**Subject: Addendum to Corrective Action Plan
Sunol Tree Gas
3004 Andrade Road, Sunol
Fuel Leak Case No. RO0002448**

This Addendum to the *Draft Corrective Action Plan (CAP)* for the subject site dated December 15, 2010 is submitted in response to your technical comments regarding this document contained in a letter dated January 26, 2011. For ease of your review, responses to your comments are provided in the same order that you presented them.

ATTACHMENT B
Well Log and Sampling Data for
Replacement Well EB-2

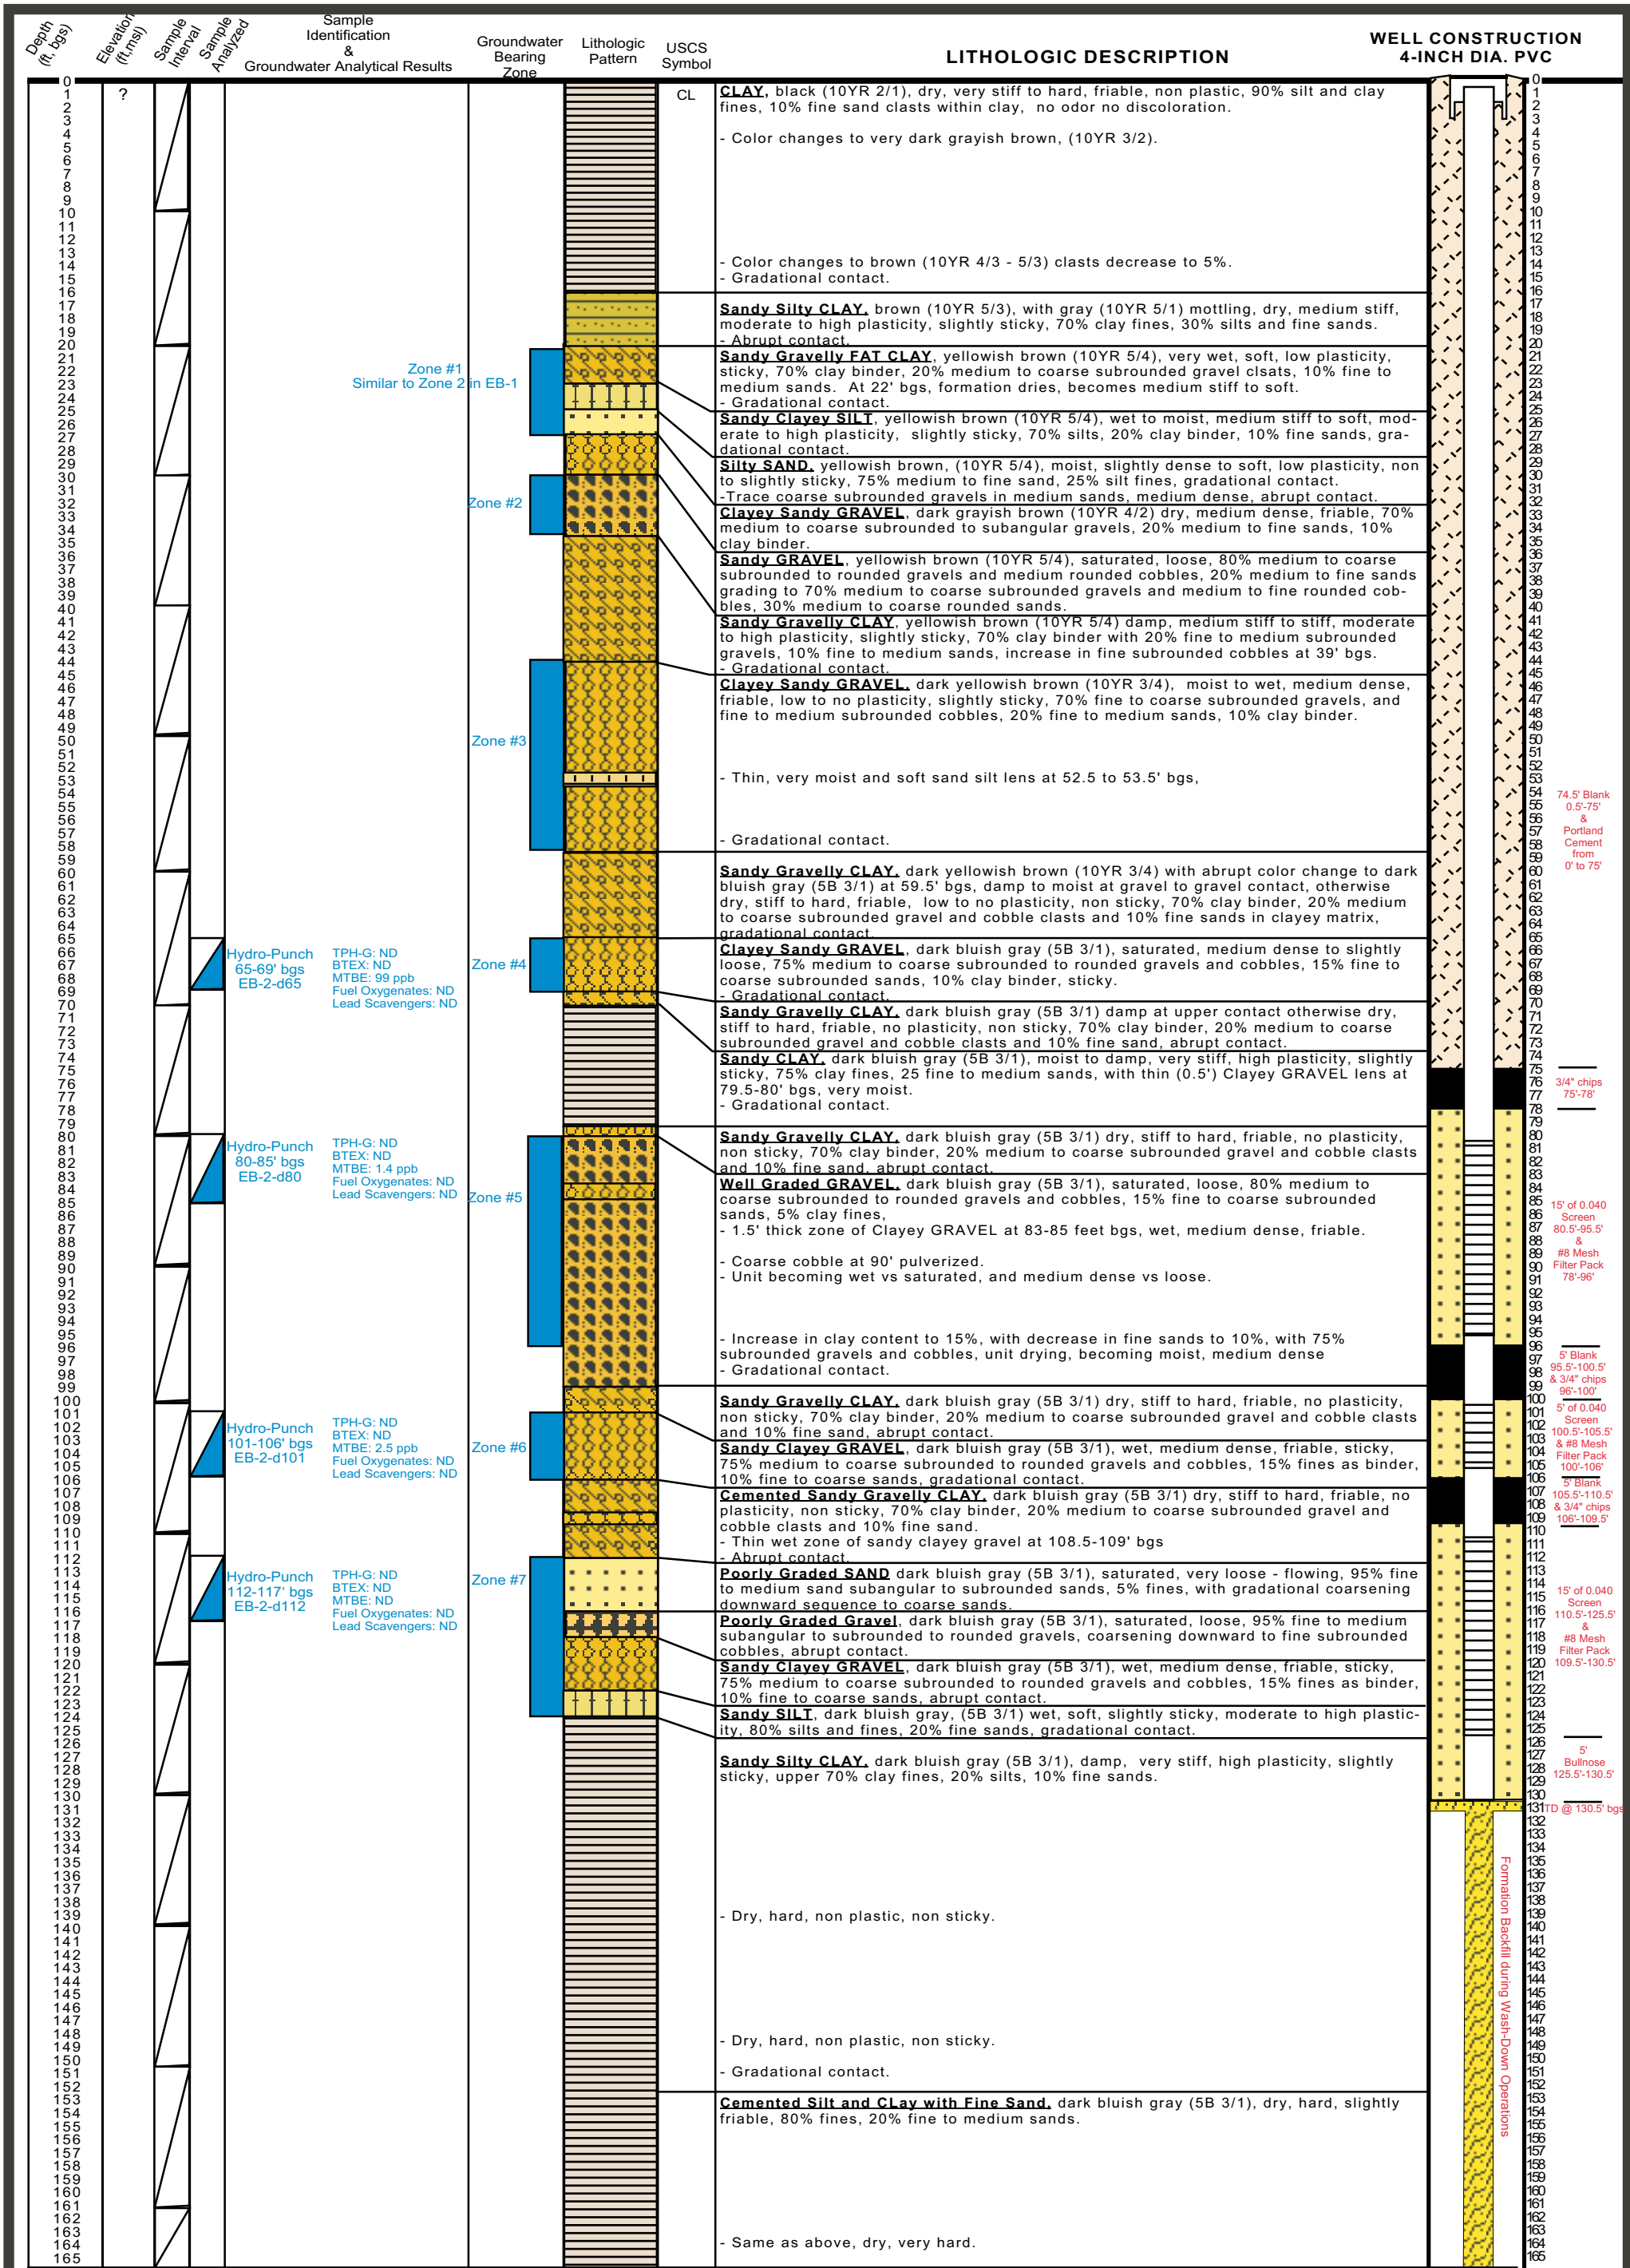
10. **Well EB-2.** – *Sampling location EB-2 is identified as a Replacement Well on Figure 2 of the September 10, 2010 report entitled, "Carbon System Test Results for the Well Head Carbon Treatment System," dated September 2010. In the revised Draft CAP requested below, please discuss whether a well is present at EB-2 and its status.*

Well EB-2 was installed by Weber-Hayes Associates in March 2006. This well was intended to be a replacement water supply well for the T-Bear Ranch and was drilled using resonant sonic technology. The technology provided undisturbed cores that yielded a very good description of subsurface lithology. The well was completed with a 4-inch diameter, PVC casing and is 135 feet deep and is screened through sandy gravel water bearing zones from 80.5 to 95.5 fbg, from 100.5 to 105.5 fbg and from 110.5 to 125.5 fbg. The well log for EB-2 is provided in **Attachment B**.

Depth discrete sampling was conducted prior to installation of a submersible pump. MtBE was detected at depth in this well (see **Table 4** in **Attachment B**). The use of this well as a replacement well was put on hold until the MtBE plume is cleaned up. Currently, BE-2 is considered a backup, emergency supply to be used only if the shallow T-Bear well will not provide an adequate water supply.
